CRAIG SEAPLANE BASE EXPANSION

PROJECT No. 69956
A.I.P. # 3-02-0071-01

DATE: JULY 1994

FLOAT PLAN

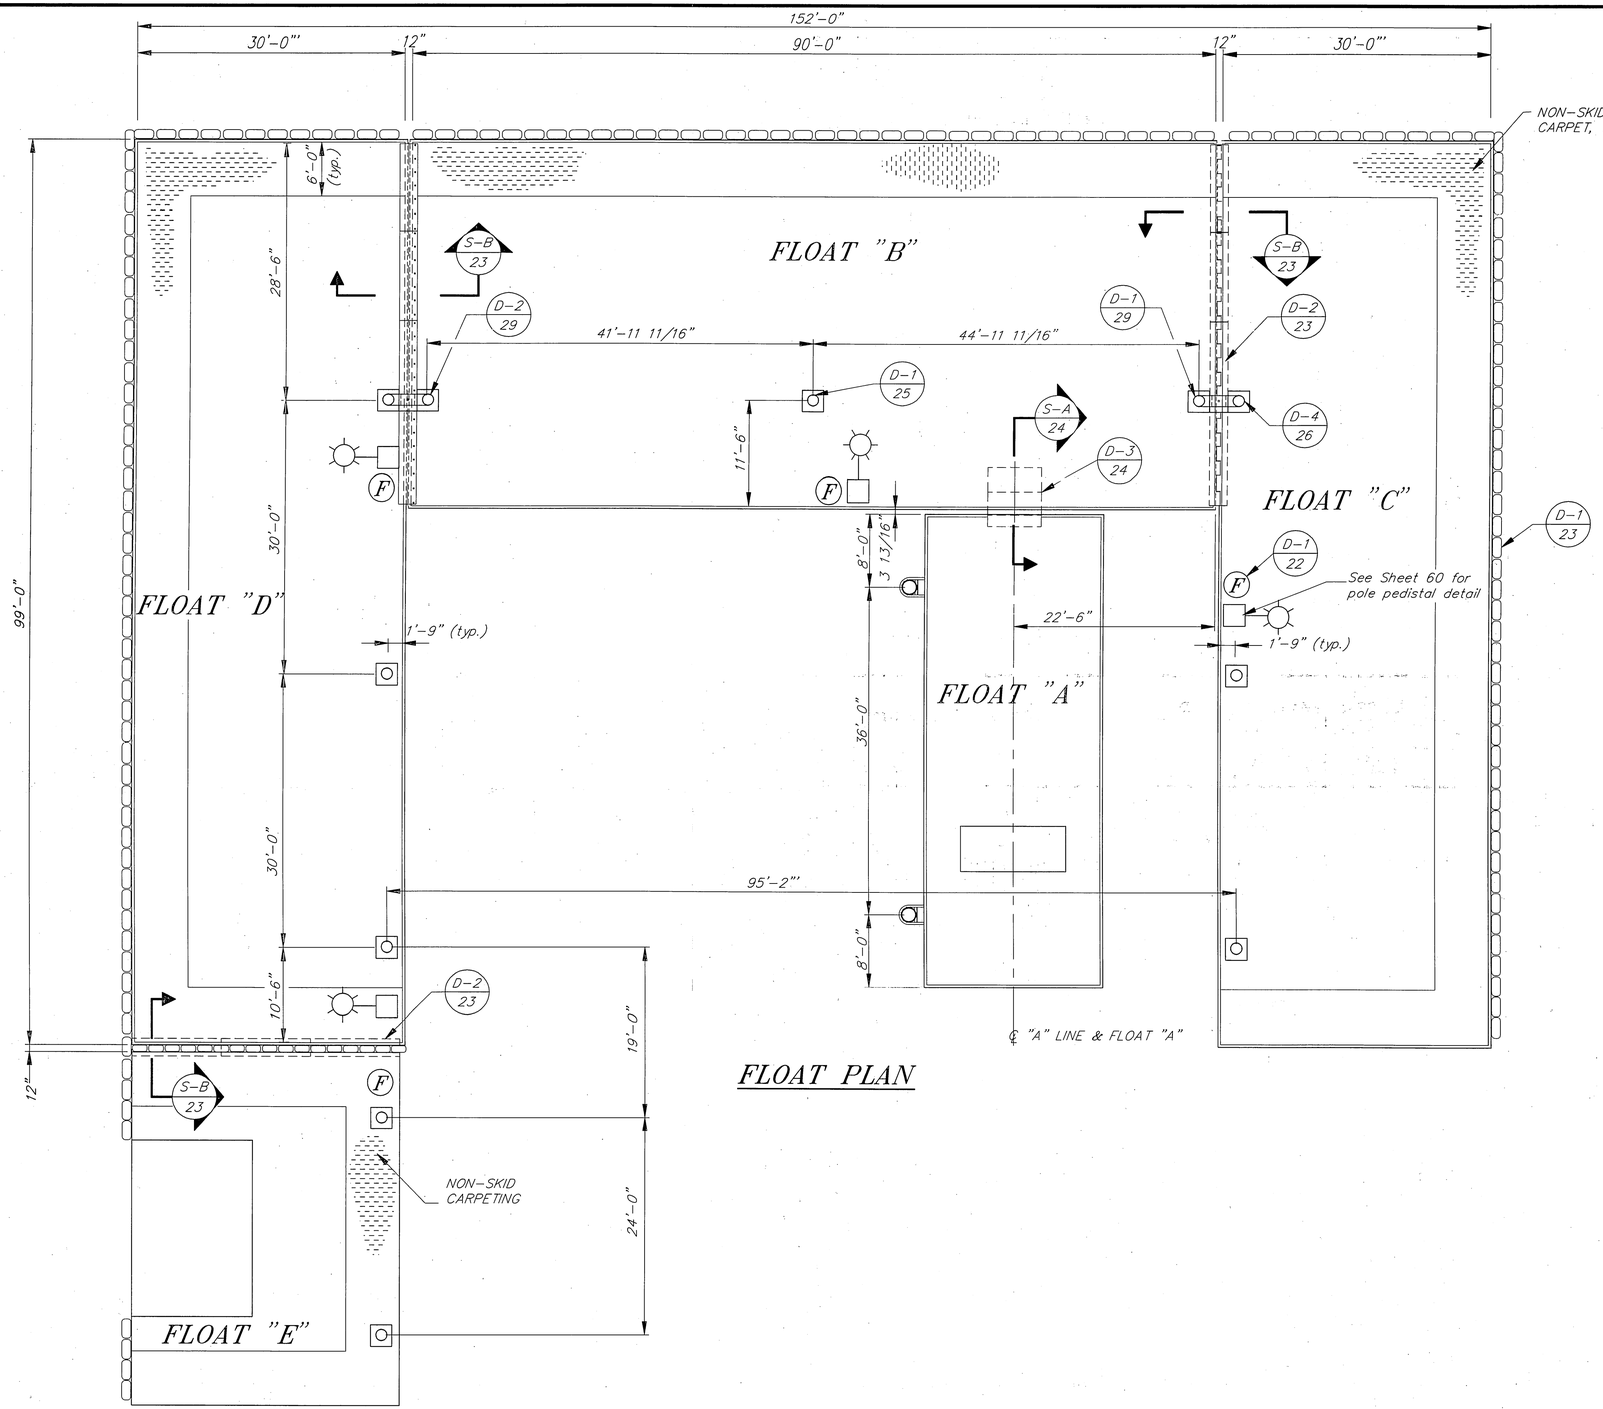
BY	DATE	DESCRIPTION OF CHANGE
DDS	8/31/94	PILE COLLARS FOR FLOAT A, WERE RELOCATED TO THE
		OTHER SIDE. LUMINAIRE POLE FOR FLOAT B WAS MOVED
		CLOSER TO FLOAT EDGE (ADDENDUM NO. 1)

FRAMING PLAN

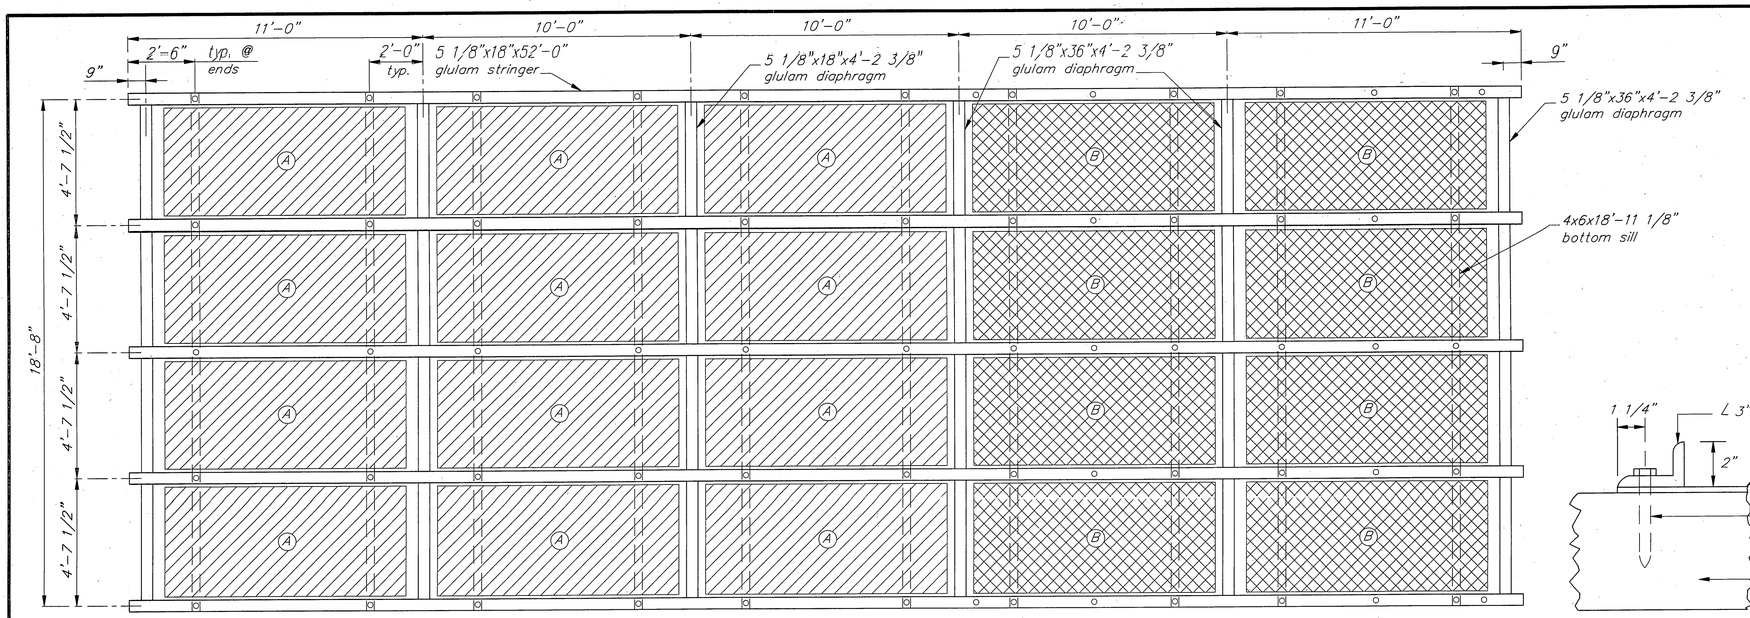
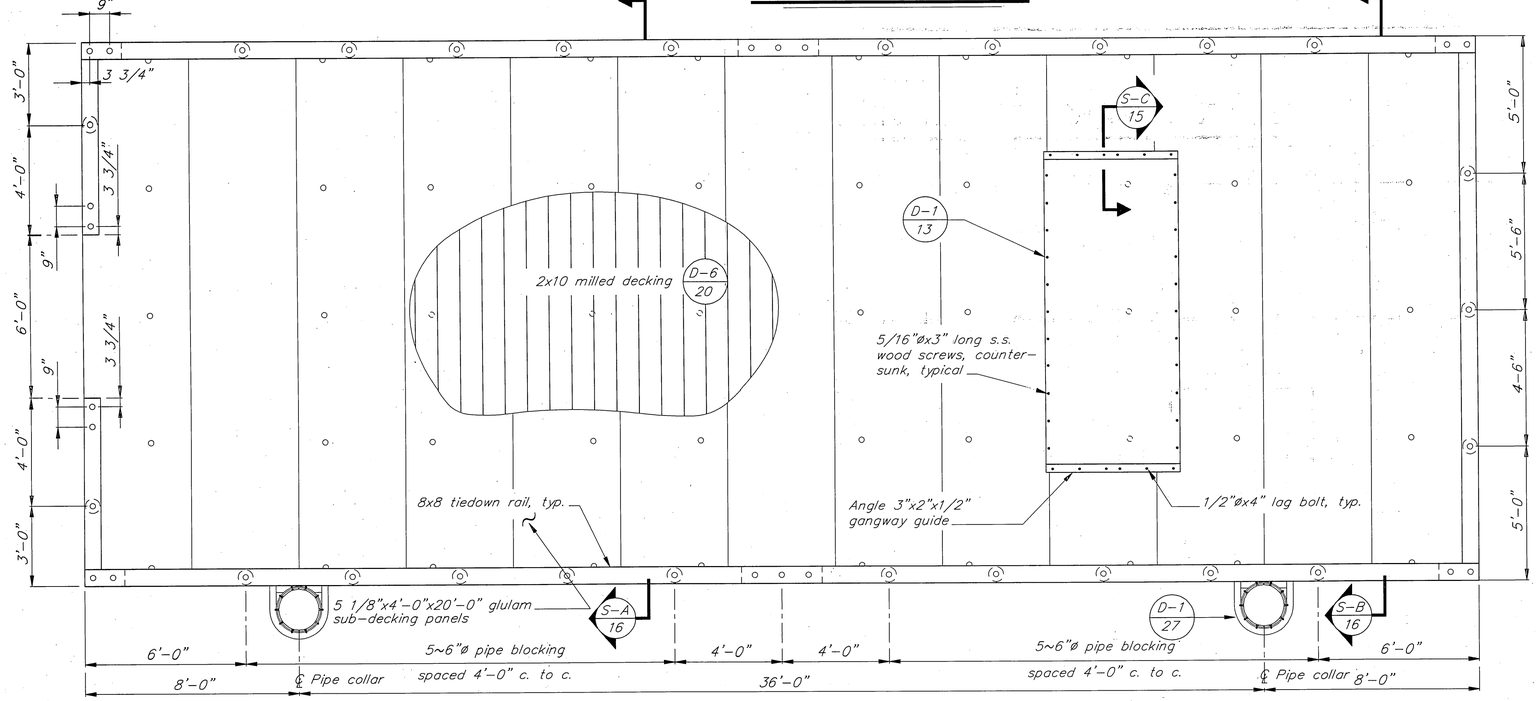
PATH : P:\CRG\SEAFLT\DR\SHT15.dwg < 1=32 >		
BY	DATE	DESCRIPTION OF CHANGE
DDS	8/31/94	THE PILE COLLARS WERE MOVED TO THE OTHER SIDE OF THE FLOAT (ADDENDUM NO.1).

ELEVATION

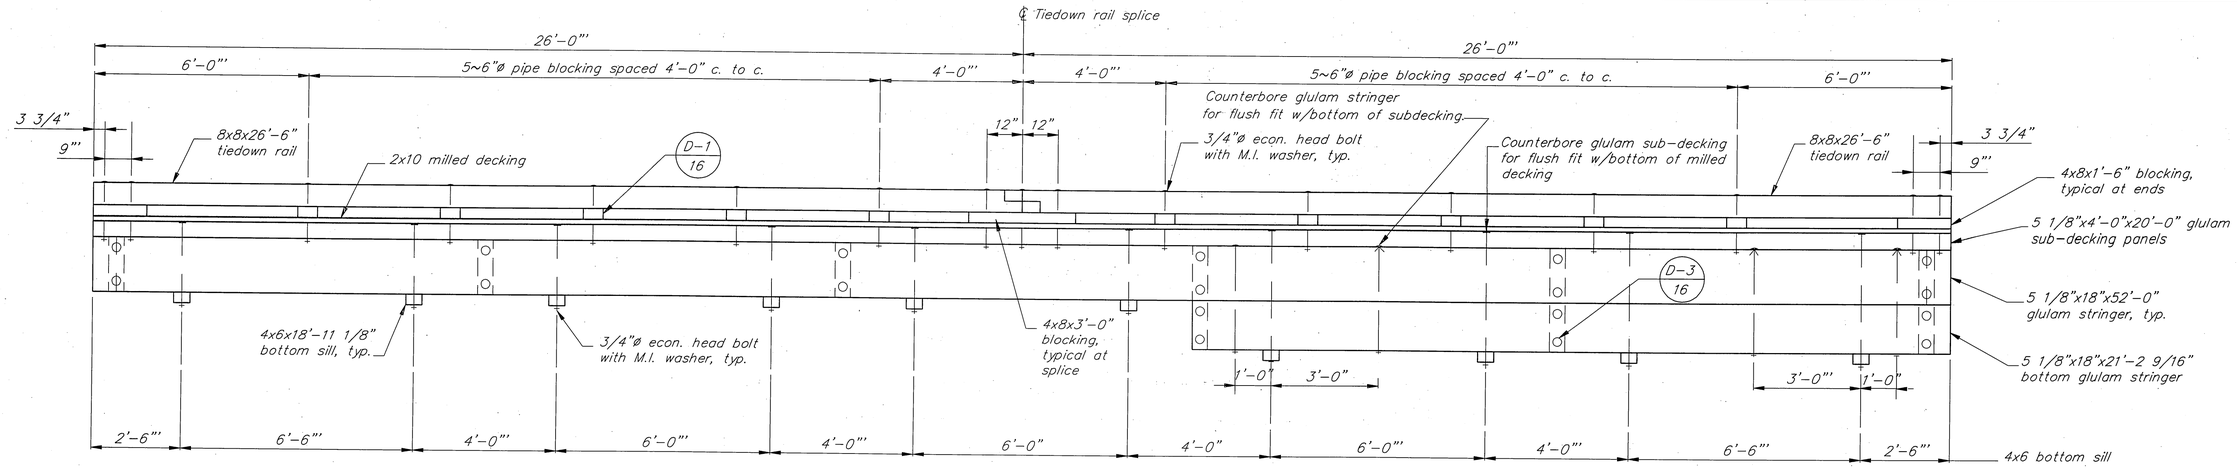
PATH : P: \CRG\SEAFLT\DR\SHT16.dwg < 1=24 >		
BY	DATE	DESCRIPTION OF CHANGE
DDS	8/31/94	THE PILE COLLARS WERE MOVED TO THE OTHER SIDE
		(ADDENDUM NO. 1)

SIGN "B" — 1 REQUIRED — 2

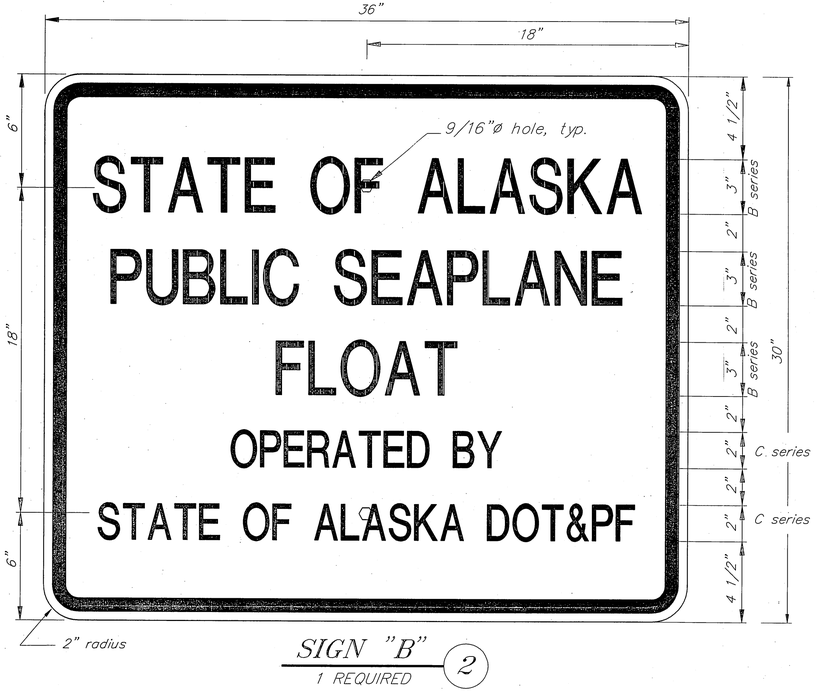
BY	DATE	DESCRIPTION OF CHANGE
DDS	9/16/94	SIGN B SHOULD READ
		"OPERATED BY STATE OF ALASKA DOT&PF"
		(ADDENDUM NO. 3)
